SEATTLE PACIFIC UNIVERSITY DRAFT MIMP OVERVIEW

DAC Meeting **May 17, 2023**

Potential new buildings show exact SF.

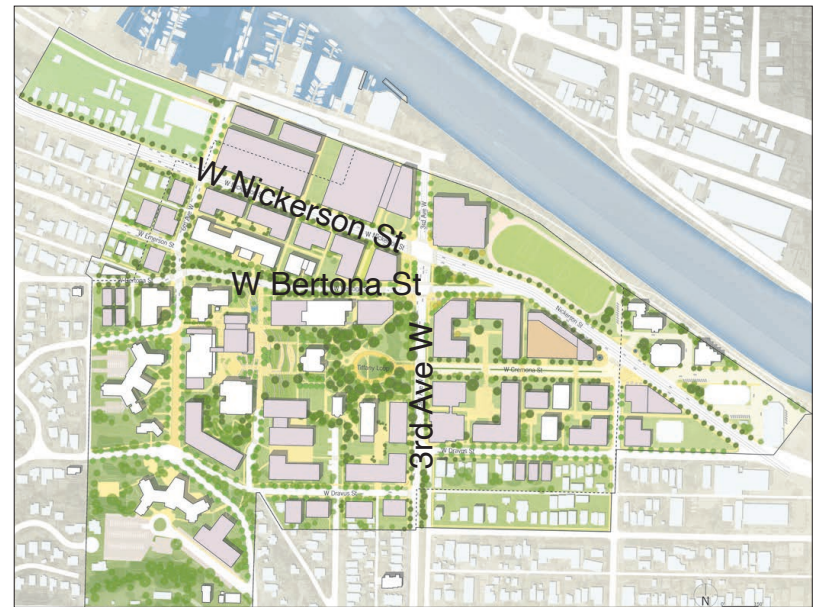
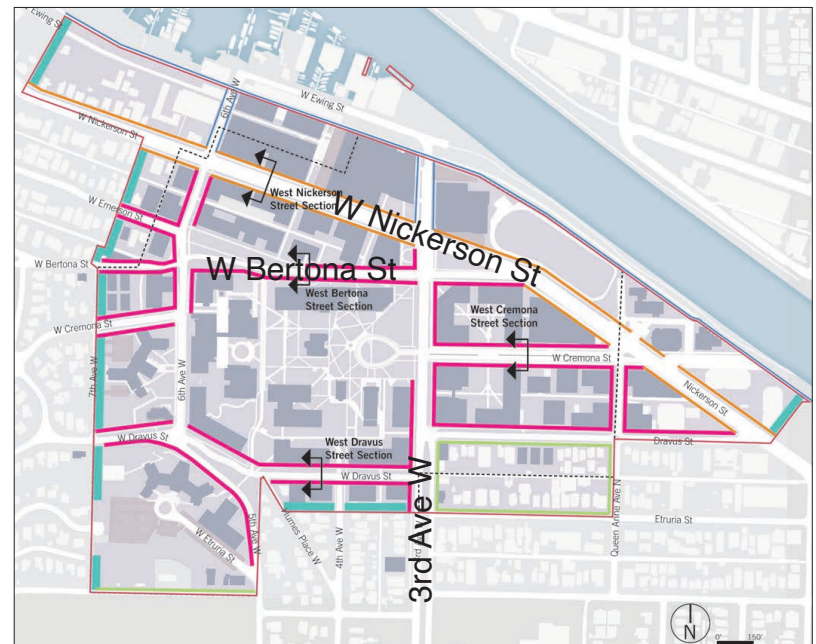
- Distinguish between illustrative maps and maps showing actual square footage (SF).

- Base maps are drawn to scale.
- All potential new development buildings show actual SF.
- All existing buildings, parcels, and zoning districts show approximate SF.*
- Need site survey to have exact SF for existing conditions, which is not an appropriate investment at the planning stage.
- Other diagrams, such as landscape and setbacks, are drawn to illustrate concepts. Marks are proportional and are optimized for readability.
